DEVELOPMENT REVIEW COMMITTEE (DRC) COMMENT REPORT

PROJECT NAME: LA Lee YMCA Mizell Community Center

CASE NUMBER: R19004

REQUEST: Site Plan Level IV Review: Public Purpose Use for 71,737 Square Foot Community Center and Associated Parking Reduction

Existing Stormwater Assets

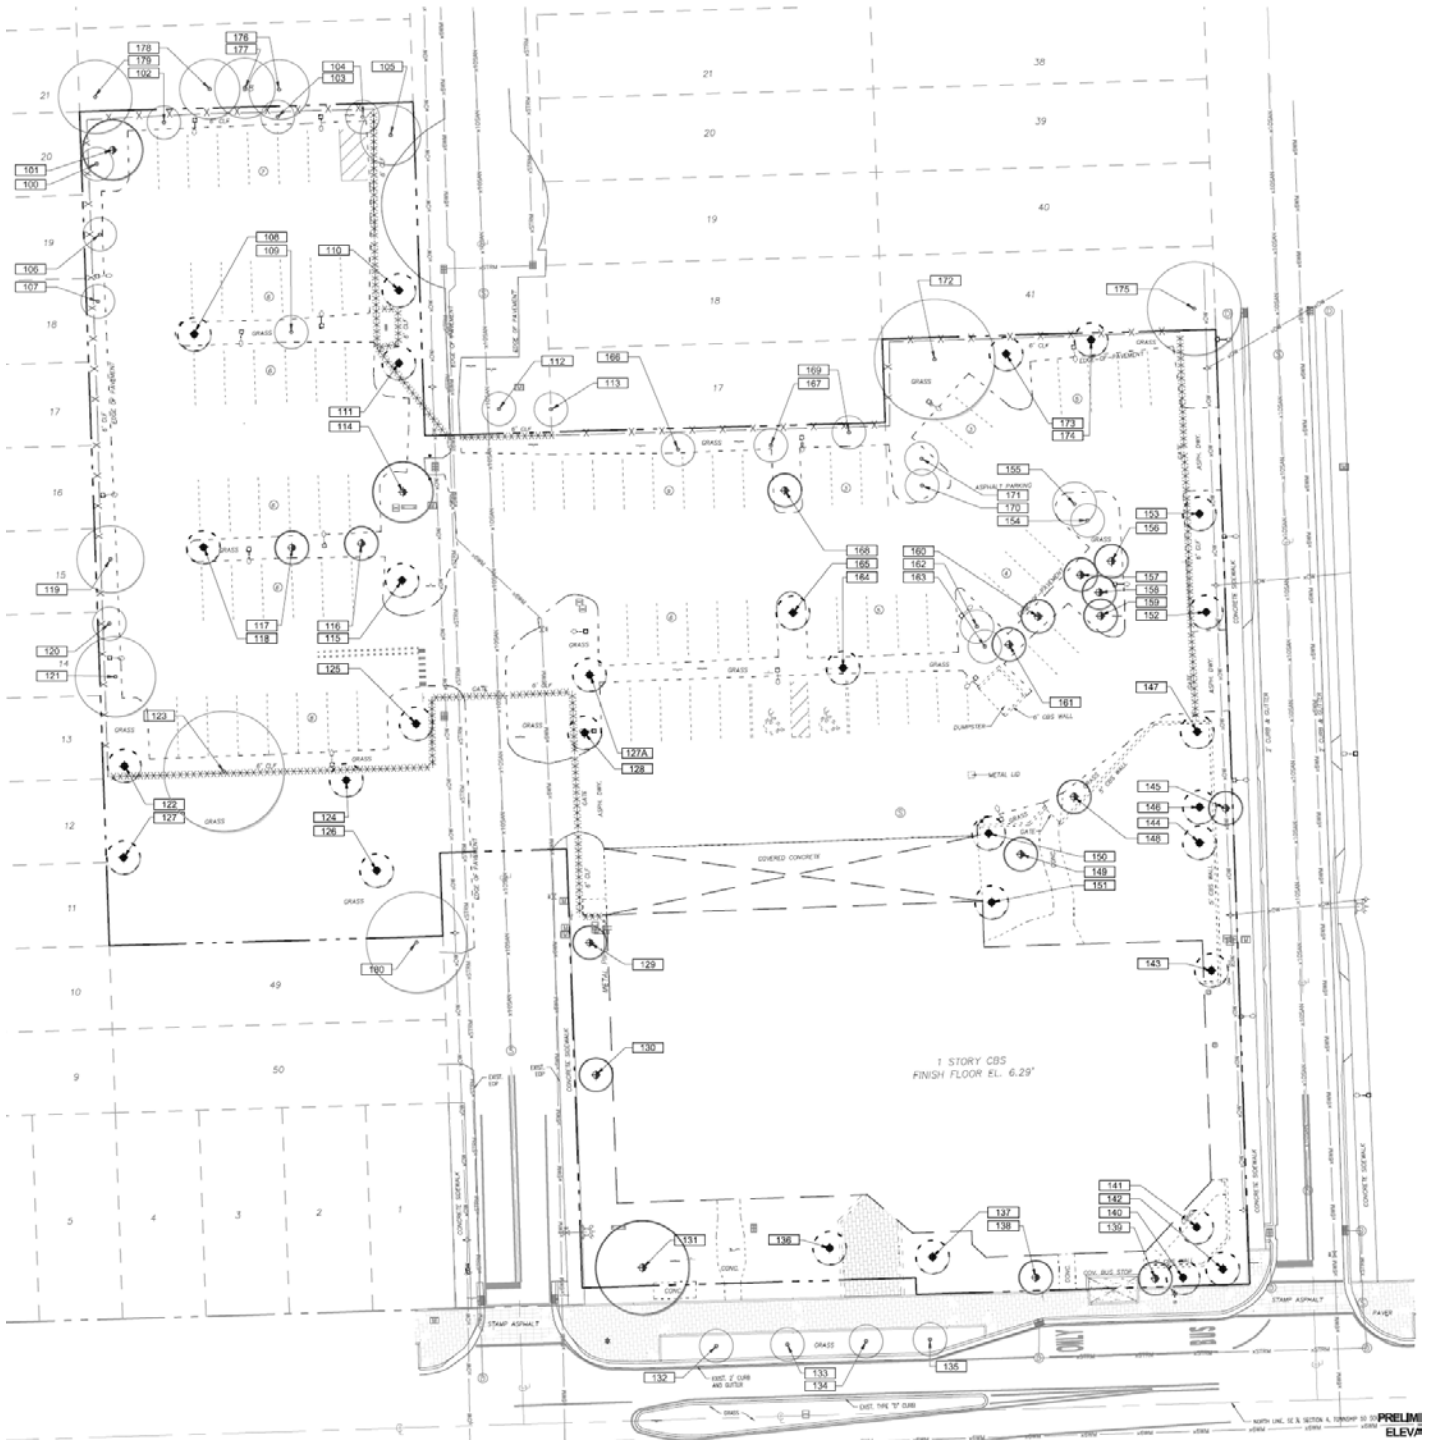
The City owns and maintains stormwater infrastructure adjacent to the proposed development as shown with green line work in the map provided at the end of this report. **Civil plans shall depict the City's stormwater inlet ID #s as identified in the map provided at the end of this report.** The following comments pertain to possible impacts of the proposed development and/or construction activities to the existing condition of the City's stormwater assets. The applicant shall provide an itemized response letter addressing the following comments:

- a) Contractor shall provide CCTV videotapes to City STW OPS of the existing stormwater system to the limits shown with green line work in the storm map provided at the end of this report in order to document the PRE and POST construction conditions of the City's storm system.
